DART AEROSPACE LTD		Work Order:	73044
Description: Crosstube High Aft (205/212)		Part Number:	D212-664-201
Inspection Dwg: D212-664-241	Rev: D		Page 1 of 1

DRAWING NO. D212-664-241	TITLE CROSSTUBE ASSY (205/212 HI AFT)	REV. D	DART AEROSPACE LTD ENGINEERING ORDER		D.E.O. NO. D212-664-241-D-1	SHEET NO. SHEET 1 OF 2	SCALE NTS
DRAWN	CHECKED	MFG. APPR.	APPROVED	DE APPR.			
DATE 11.04.07	DATE 11.04.11	DATE 11.04.12	DATE 11/04/12	DATE 11.04.12

DRAWING NO. D212-664-241	TITLE CROSSTUBE ASS'Y (205/212 HI AFT)	REV. D	DART AEROSPACE LTD ENGINEERING ORDER		D.E.O. NO. D212-664-241-D-2	SHEET NO. SHEET 1 OF 1	SCALE NTS
DRAWN <i>q</i>	CHECKED <i>ASS</i>	MFG. APPR. <i>SS</i>	APPROVED <i>MD</i>		DE APPR. <i>MD</i>		
DATE 11.07.15	DATE 11.07.20	DATE 11.07.21	DATE 11/07/21		DATE 11-07-21

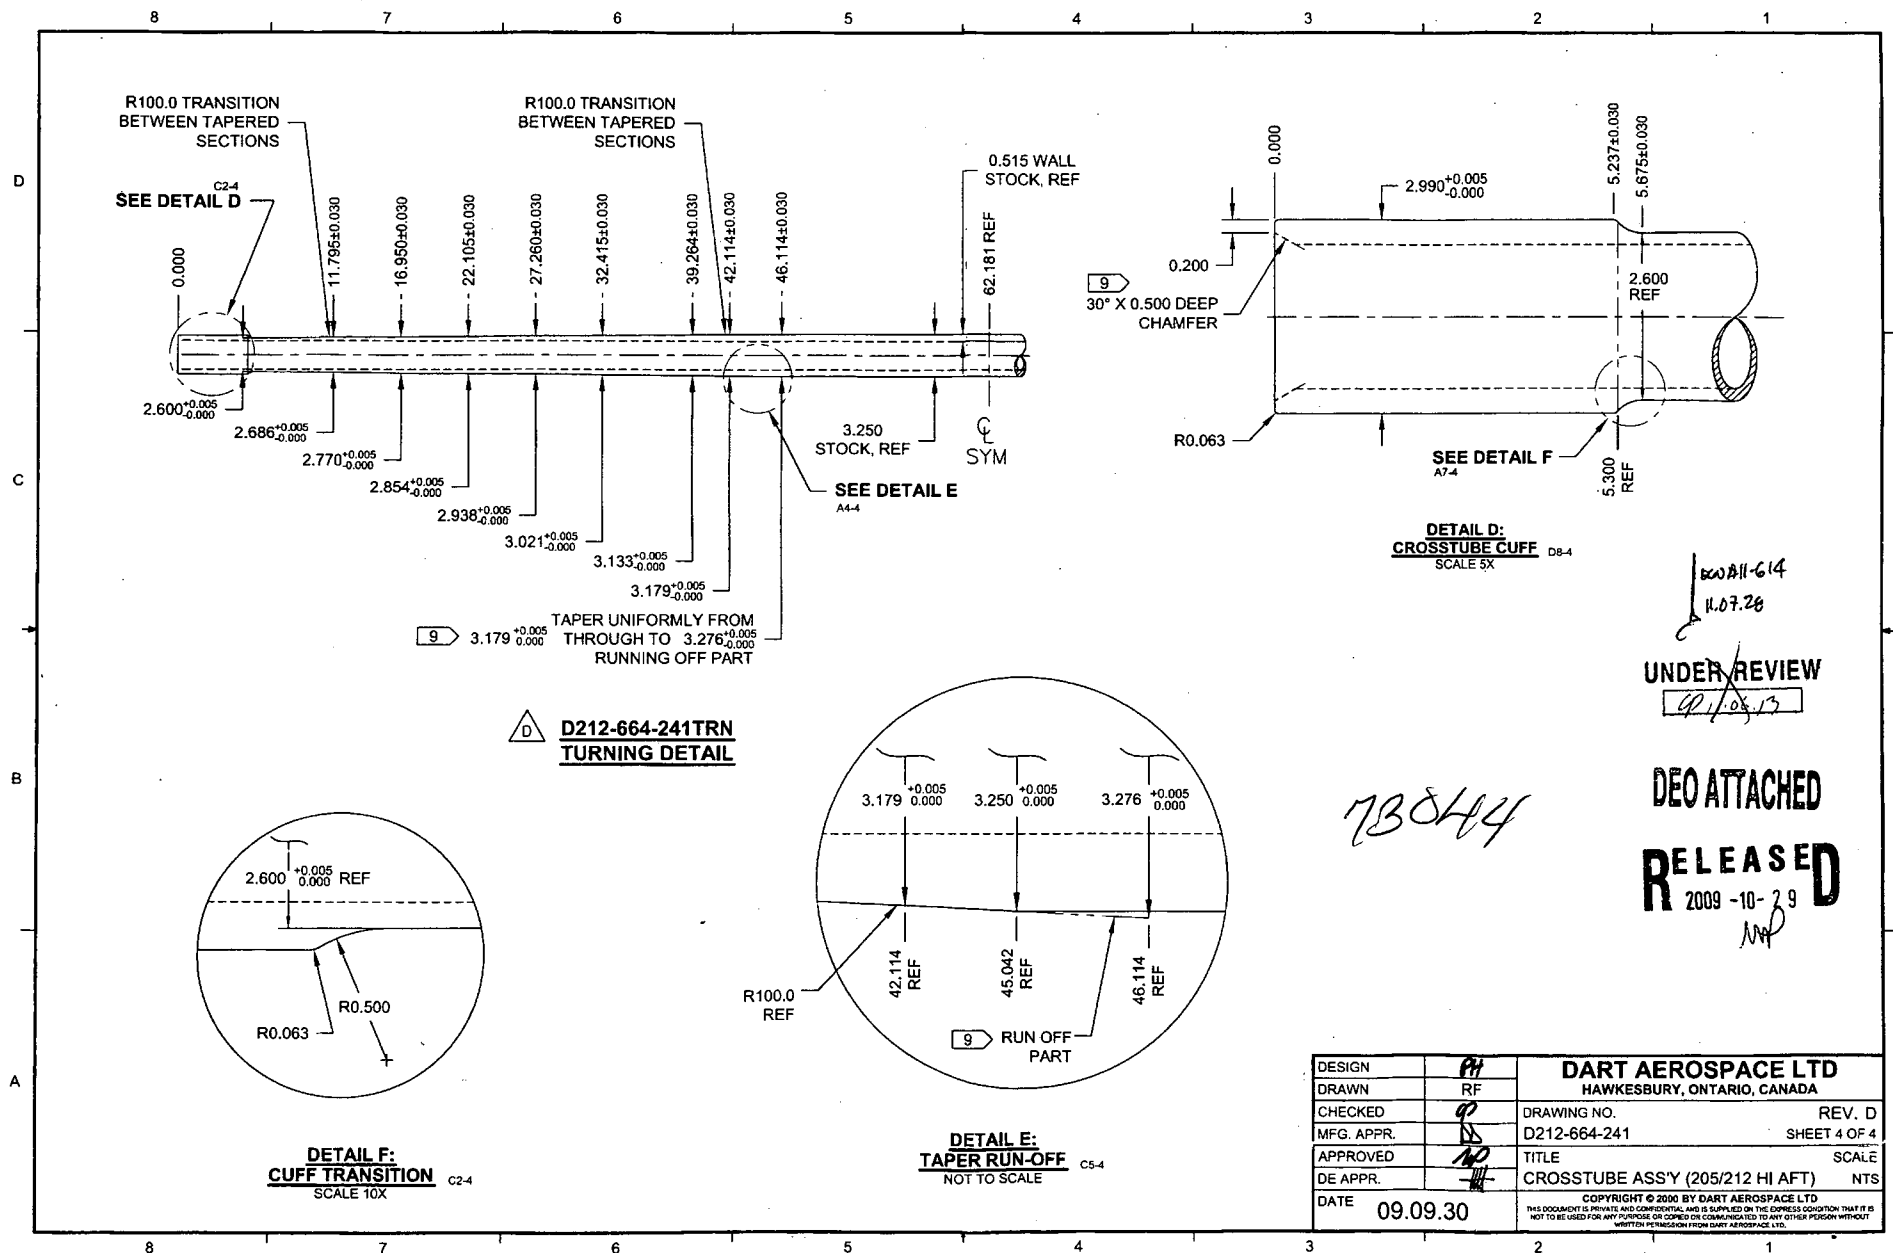
PURPOSE:

ADD AN INSPECTION WINDOW TO UNDERSIDE OF CROSSTUBE.

- 2) FINISH: CHEMICAL CONVERSION COAT PER DART QSI 005 4.1
PRIME INSIDE AND OUTSIDE PER DART QSI 005 4.2
MASK UNDERSIDE OF CROSSTUBE AS SHOWN (HATCHED AREA) AND
PAINT OUTSIDE PER DART QSI 005 4.2
REMOVE MASKING AND APPLY CLEAR COAT

D212-664-241/-241B
ASSEMBLY DETAIL

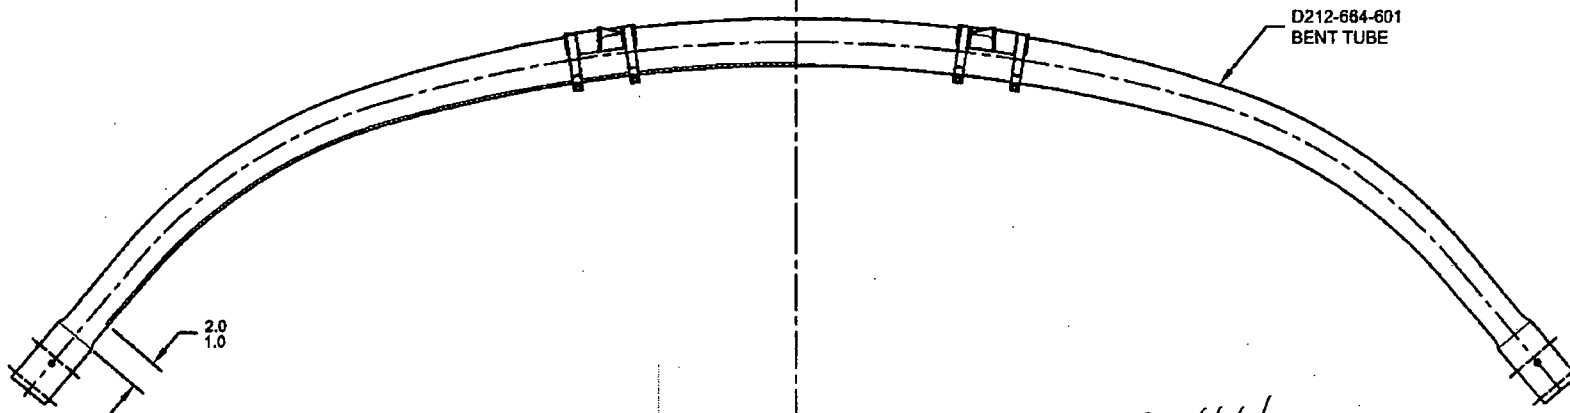
CHANGE:

NOTES 2 OF SHEET 1 IS AMENDED AS FOLLOWS:

IS:

WAS:

IS:

MASK AREA PRIOR TO PAINTING,
REMOVE MASKING AFTER PAINT
AND APPLY CLEAR COAT
